<b>Title - Sujet</b> Palace Grand Theatre Renovation	
<b>Solicitation No. - N° de l'invitation</b> EZ899-171574/A	<b>Amendment No. - N° modif.</b> 006
<b>Client Reference No. - N° de référence du client</b>	<b>Date</b> 2016-12-02
<b>GETS Reference No. - N° de référence de SEAG</b> PW-\$PWY-028-7894	
<b>File No. - N° de dossier</b> PWY-6-39183 (028)	<b>CCC No./N° CCC - FMS No./N° VME</b>
<b>Solicitation Closes - L'invitation prend fin</b> <b>at - à 02:00 PM</b> <b>on - le 2016-12-15</b>	<b>Time Zone</b> <b>Fuseau horaire</b> Pacific Standard Time PST
<b>F.O.B. - F.A.B.</b> <b>Plant-Usine:</b> <input type="checkbox"/> <b>Destination:</b> <input checked="" type="checkbox"/> <b>Other-Autre:</b> <input type="checkbox"/>	
<b>Address Enquiries to: - Adresser toutes questions à:</b> Lam (PWY), Tian	<b>Buyer Id - Id de l'acheteur</b> pwy028
<b>Telephone No. - N° de téléphone</b> (604) 775-9382 ( )	<b>FAX No. - N° de FAX</b> (604) 775-6633

The Solicitation Amendment 006 is raised to incorporate Addendum No. 3

Please find Addendum A003 herein

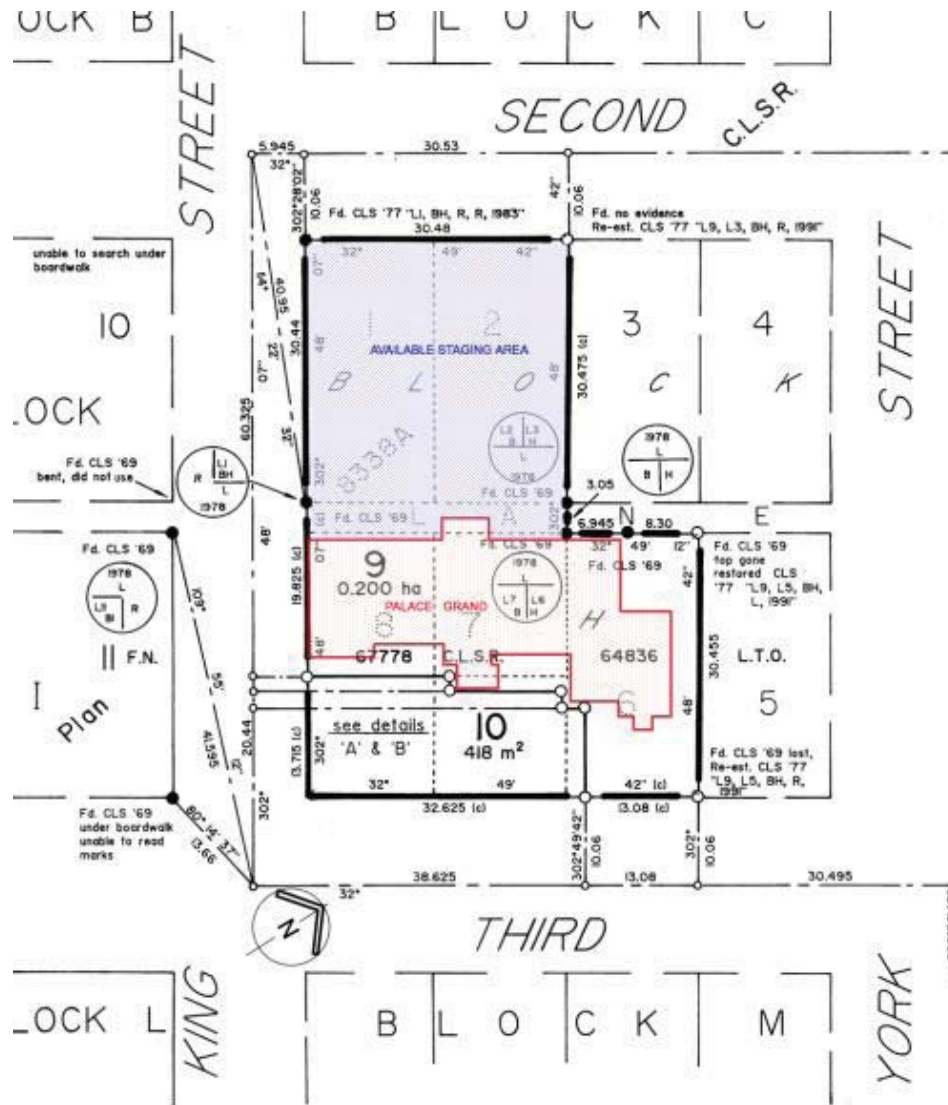
<b>Q1</b>	<u>Bidder</u>	<u>Question</u>	<u>Question Date</u>
	NGC Builders		Nov 24 -2016, email
		<i>'I am looking for contact information regarding the lot adjacent to the Palace Grand Theatre in Dawson City.</i>	
		<i>We would like to discuss arrangements for availability for staging during the project, as it is an empty lot.</i>	
		<i>Also, if there is a cost attached to this, we would need a value to include in our bid. I have a copy of the Certificate of Title indicating that it is Crown Land. (see attached doc)</i>	
		<i>Would you have any information as to whom to contact about this?"</i>

The two lots as depicted in the following sketch can be used for staging purposes, there will be no cost to the contractor to use these empty lots.  
After project completion, the lots should be in, as found condition or better.
